December 14, 2018

Subject: Review of San Martin RV Park Noise Barriers

Jim Brennan
President
Member: Institute of Noise Control Engineering
File: 2017-114 San Martin RV Park Barrier Review

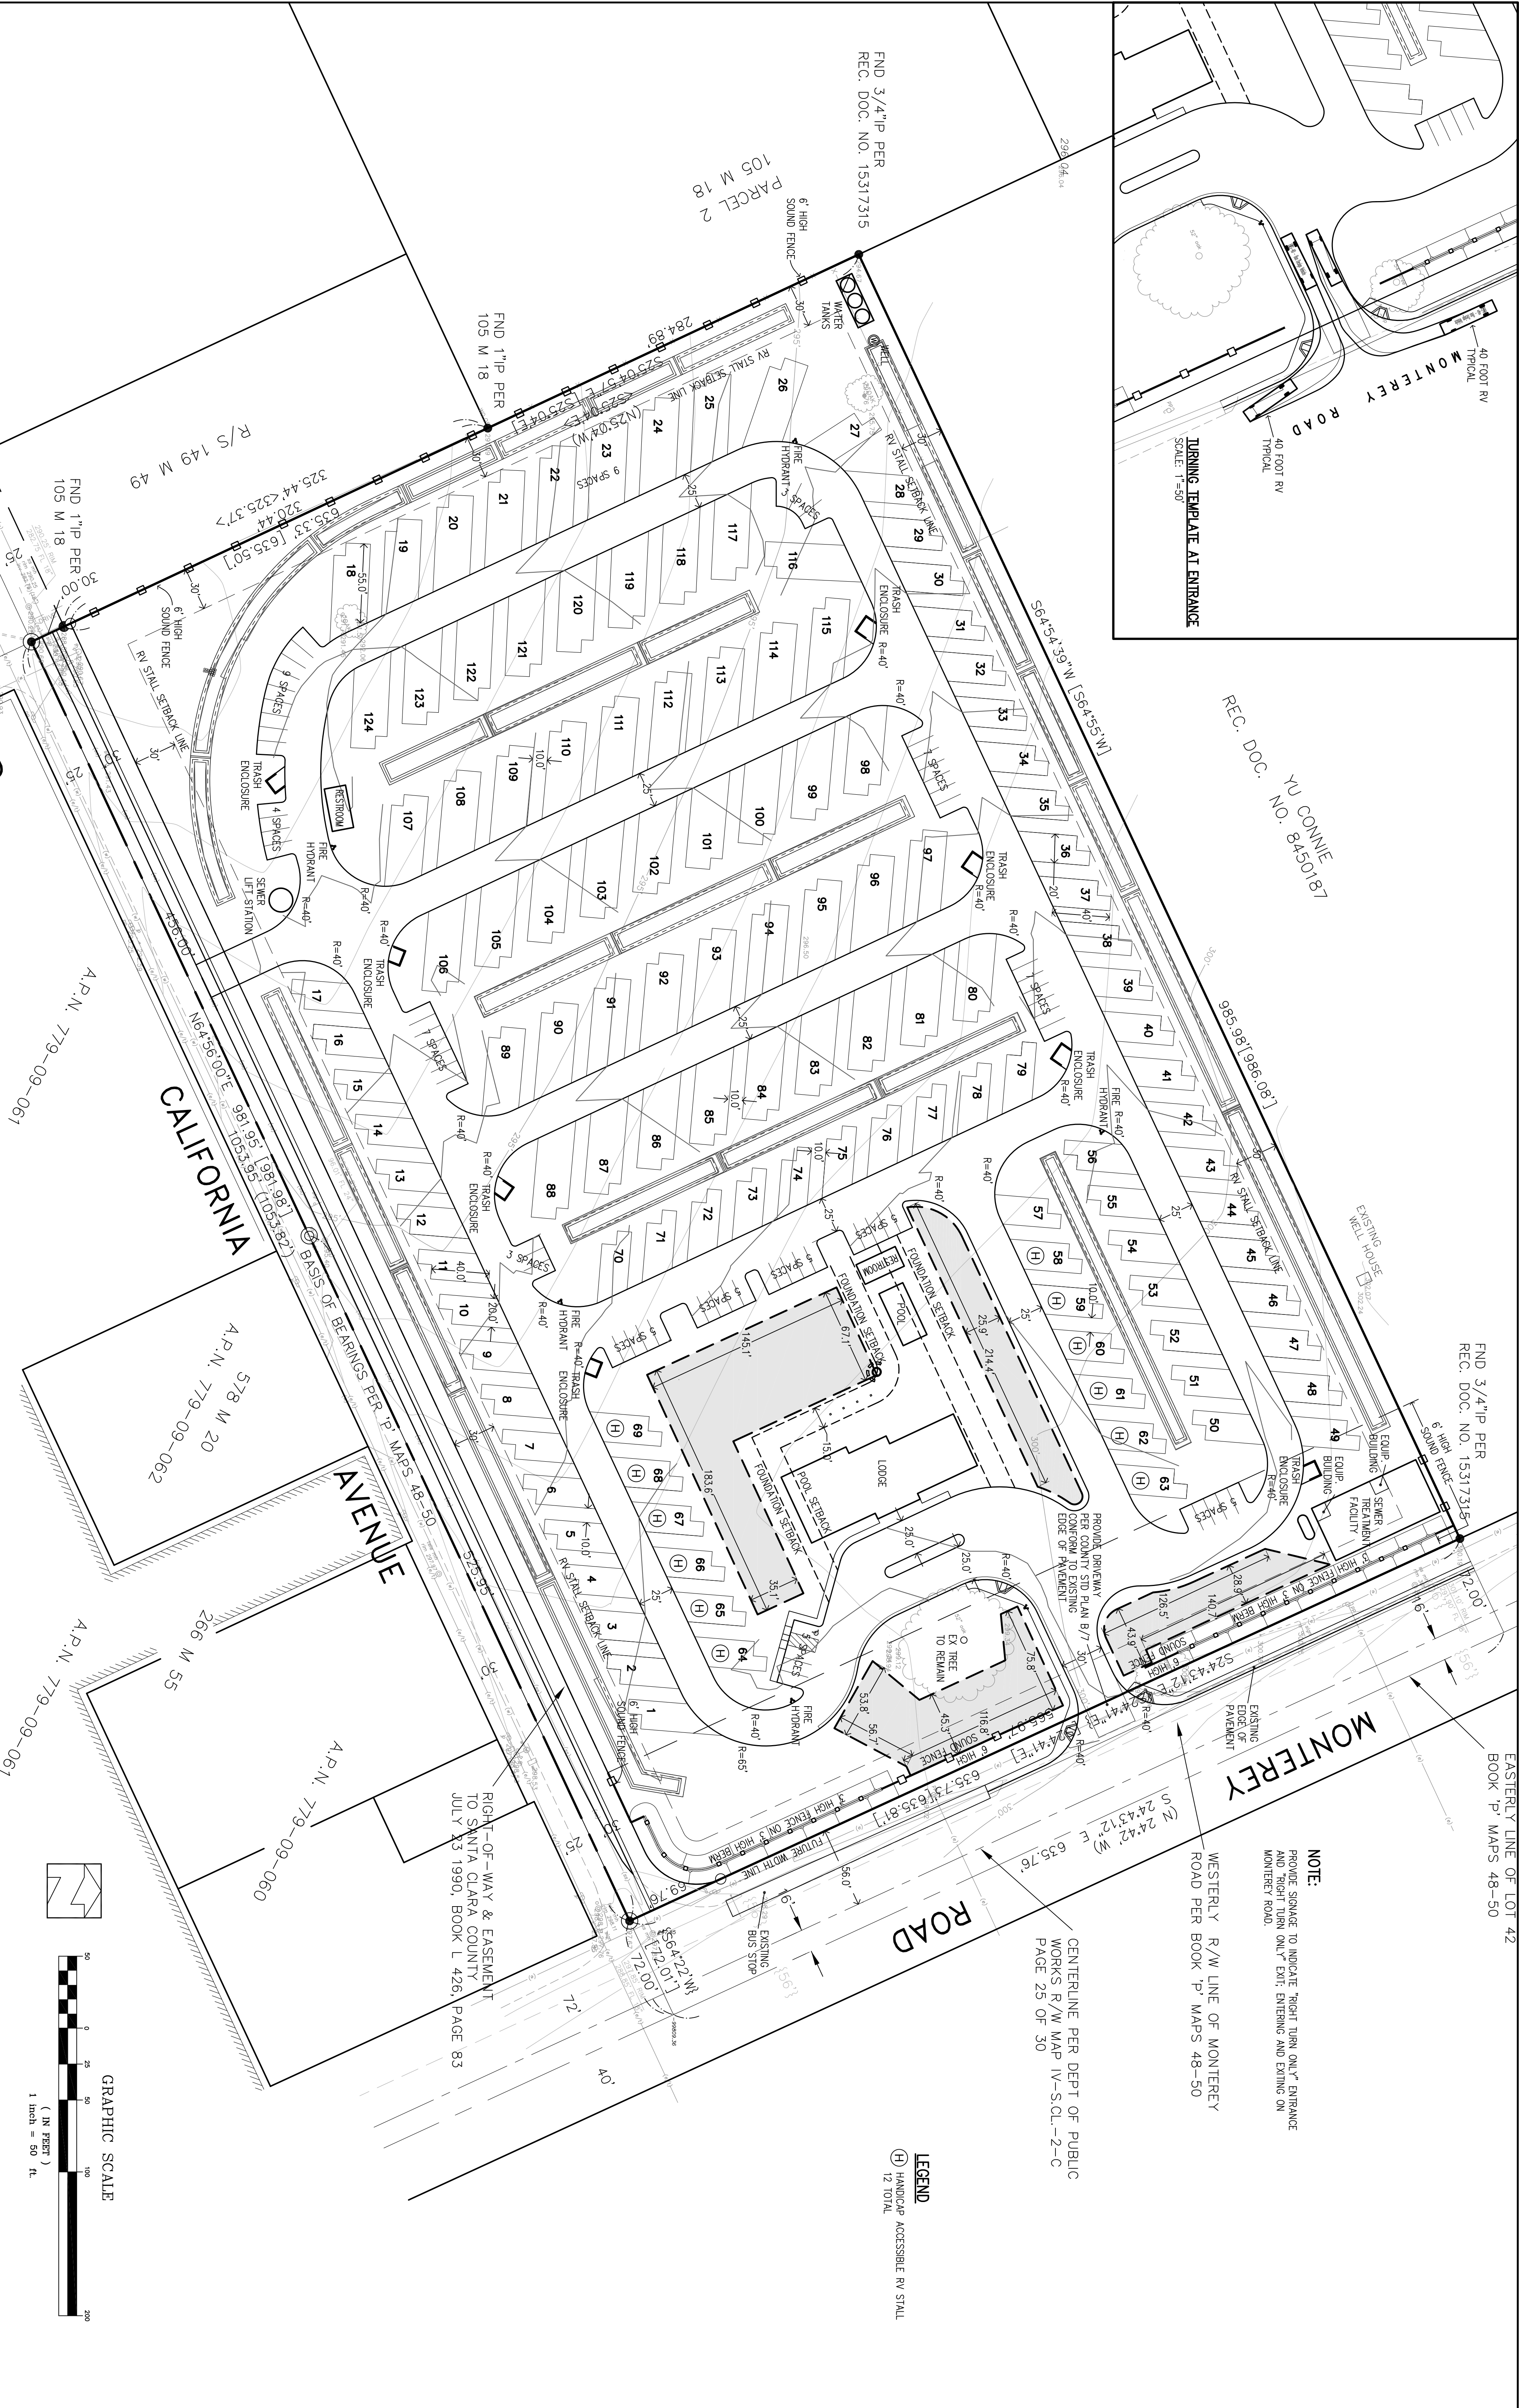
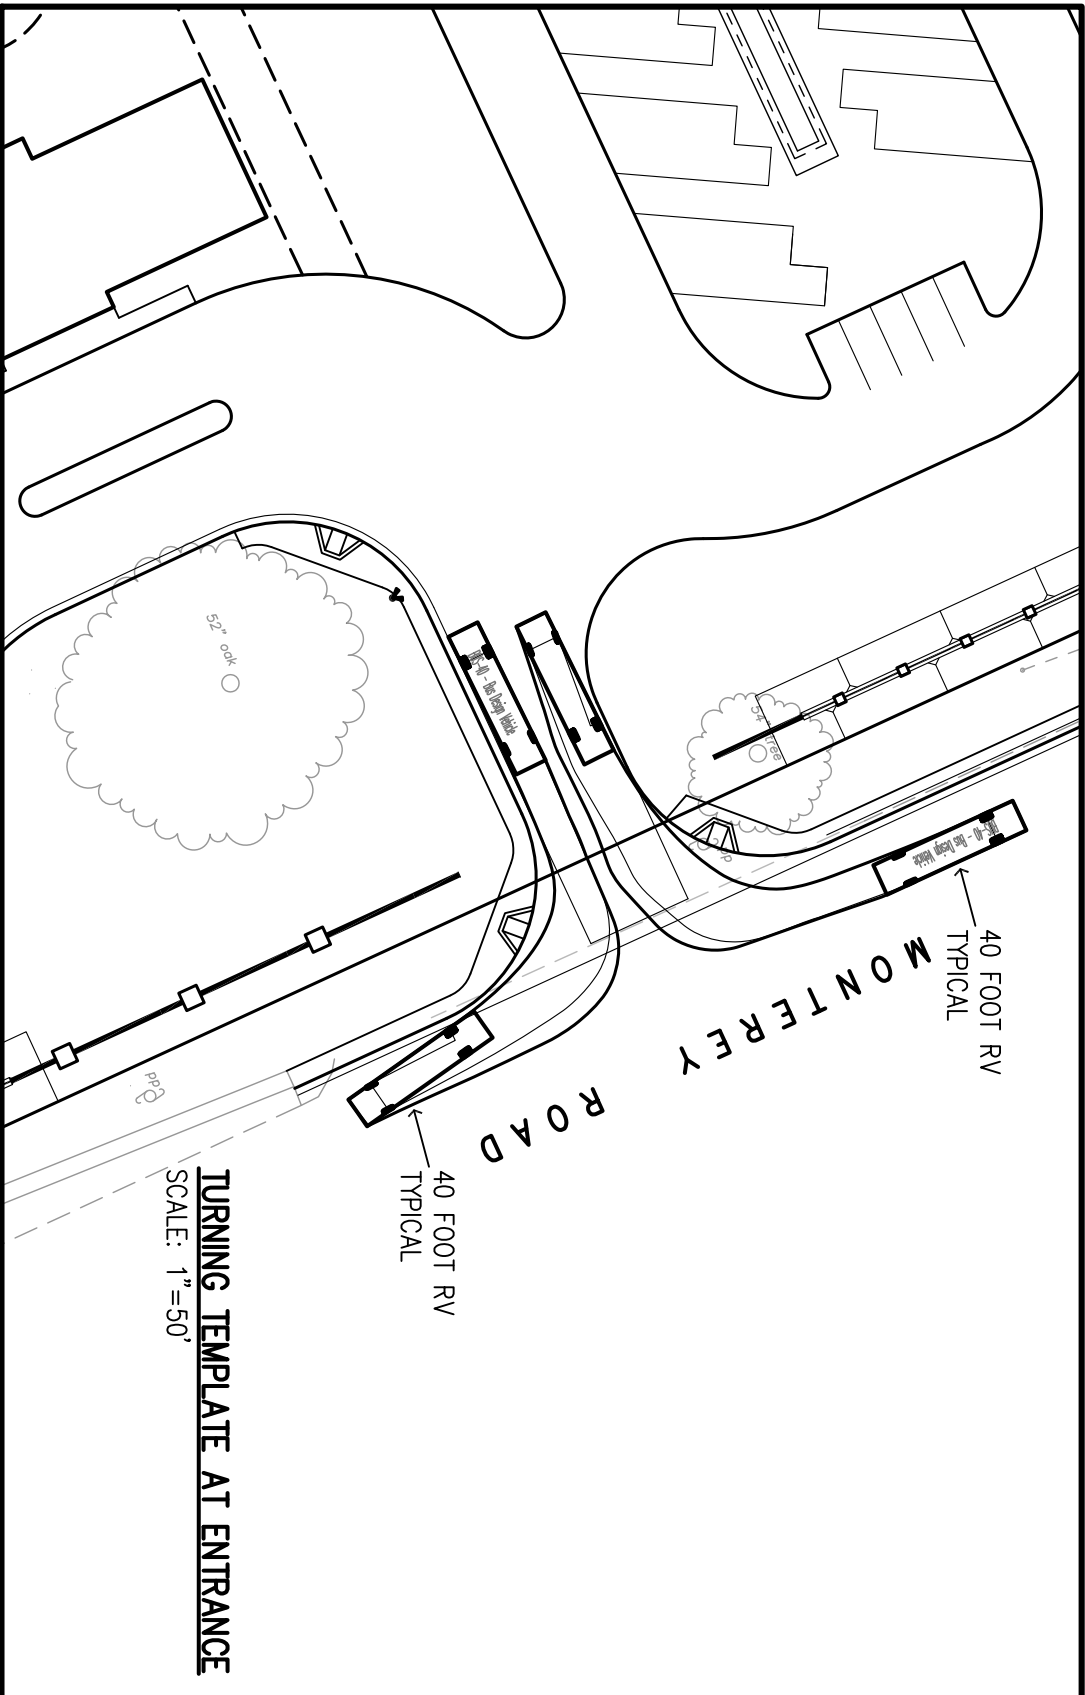
j.c. brennan & associates, Inc. has reviewed the Monterey Road barrier configuration and construction. The barrier is either a combination of a 3-foot tall berm with a 3-foot tall "smooth stone" barrier on top of the berm (total 6-feet), or a 6-foot tall smooth stone

barrier. The barrier returns approximately 50-feet at the north and south ends of the project site. The smooth stone barrier is a pre-cast concrete panel system with pilasters at 5-foot intervals. j.c. brennan & associates, Inc. conducted a barrier analysis and determined that the overall Monterey Road traffic noise levels at the nearest RV Park site would be 55 dB Ldn, and would comply with the 55 dB Ldn standard for residential uses. Interior noise levels are expected to be less than 45 dB Ldn.

Southwest Property Line Barrier

The southwest property line barrier is proposed to be 6-feet in height, and is intended to reduce overall noise levels associated with the RV Park operations at the nearest residences. The barrier will either be a precast concrete or a block wall. This is sufficient to reduce noise levels as described in the Environmental Noise Assessment.
